UNITED STATES PATENT AND TRADEMARK OFFICE

Office Action Summary

10/643,055

REUSCHE ET AL.

Fig. 1

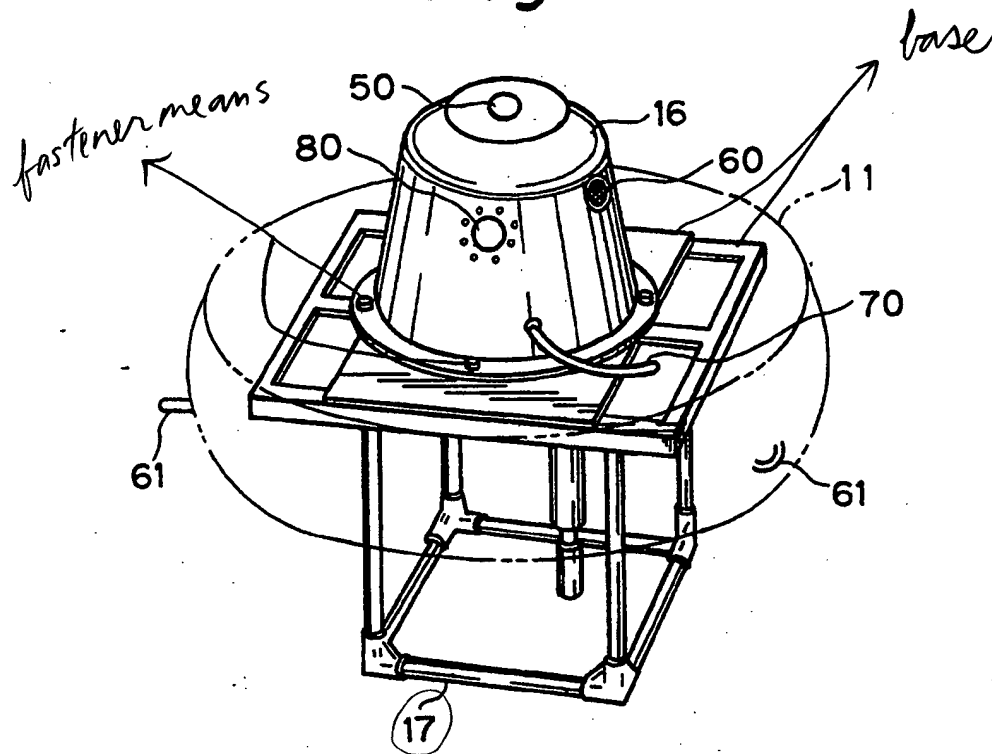
9. Applicant further argues that Kajisono does not teach a base removably interconnected to a cover, the Examiner disagrees. As shown in Figure 1, Kajisono clearly shown the a base removably interconnected to a cover (16) by fastener means (see Figure 1 attached at the end of this Office Action for further explanation).
